# HIGHWAY WORK PROPOSAL

Proposal Number: **025**

<u>COUNTY</u>	<u>STATE PROJECT</u>	<u>FEDERAL</u>	<u>PROJECT DESCRIPTION</u>	<u>HIGHWAY</u>
Door	4430-19-71	N/A	Sth 42, City Of Sturgeon Bay; S Junction Sth 57-Bayview Bridge	STH 042

## ADDENDUM REQUIRED ATTACHED AT BACK

Addendum No. 01  
ID 4430-19-71  
Revised Sheet 14  
January 27, 2022

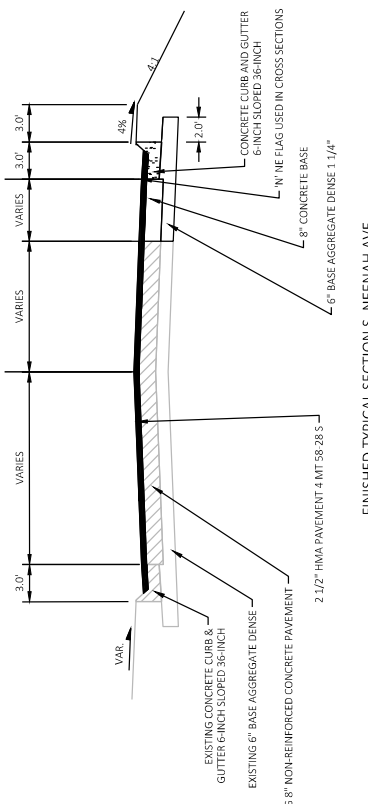
FINISHED TYPICAL SECTION S. NEENAH AVE  
STA 65+52'N TO 66+24'N

**Addendum No. 01**  
**ID 4430-19-71**  
**Revised Sheet 65**  
**January 27, 2022**

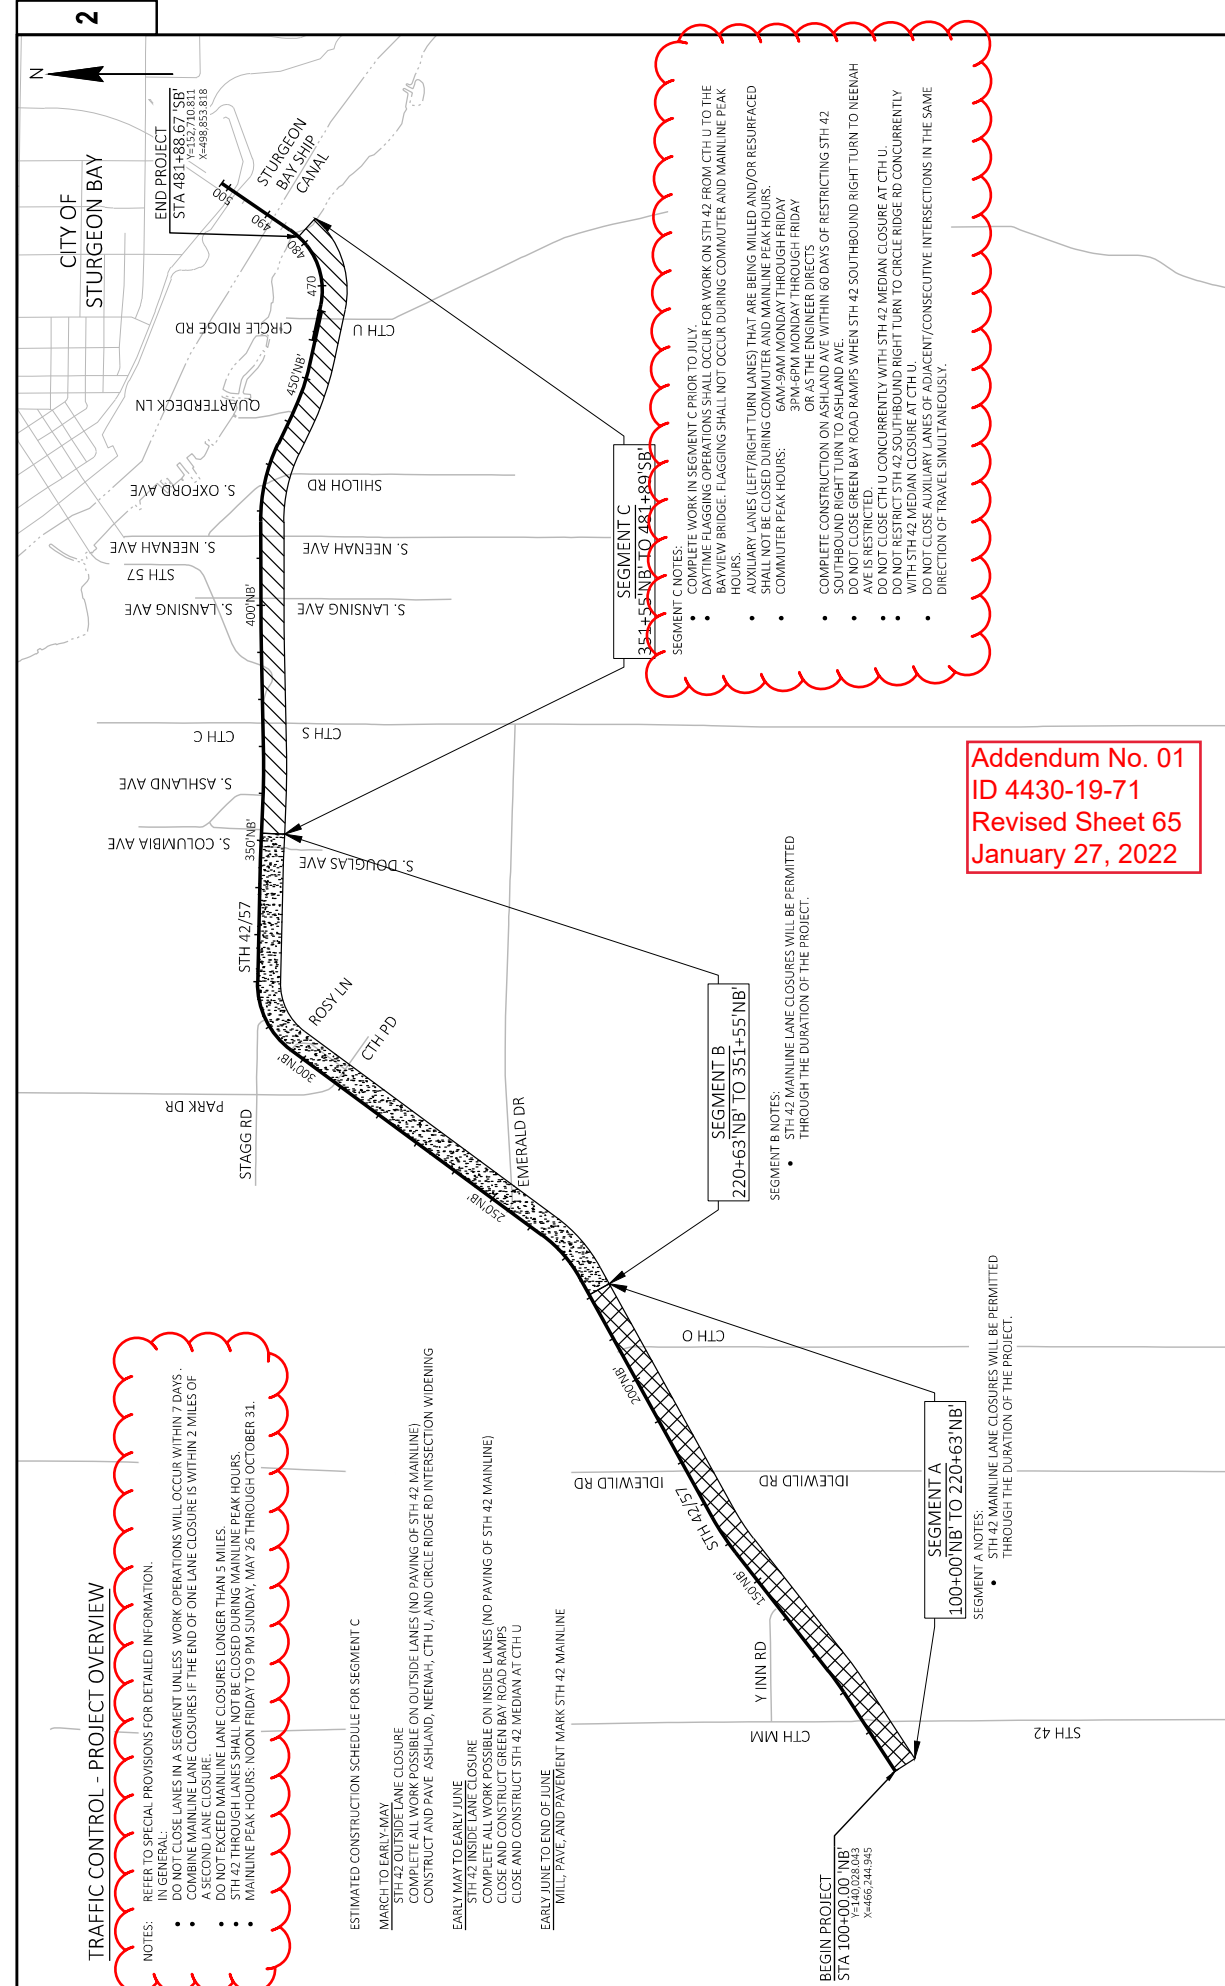
ESTIMATED CONSTRUCTION SCHEDULE FOR SEGMENT C  
 MARCH TO EARLY MAY  
 STH 42 MAINLINE CLOSURE  
 CONSTRUCTION AND PAVE ASHLAND, NEEHAH, CTH U, AND CIRCLE RIDGE RD INTERSECTION WIDENING  
 EARLY MAY TO EARLY JUNE  
 STH 42 INSIDE LANE CLOSURE  
 COMPLETE ALL WORK POSSIBLE ON INSIDE LANES (NO PAVING OF STH 42 MAINLINE)  
 CLOSE AND CONSTRUCT GREEN BAY ROAD RAMPS  
 CLOSE AND CONSTRUCT STH 42 MEDIAN AT CTH U  
 EARLY JUNE TO END OF JUNE  
 MILL, PAVE, AND PAVEMENT MARK STH 42 MAINLINE
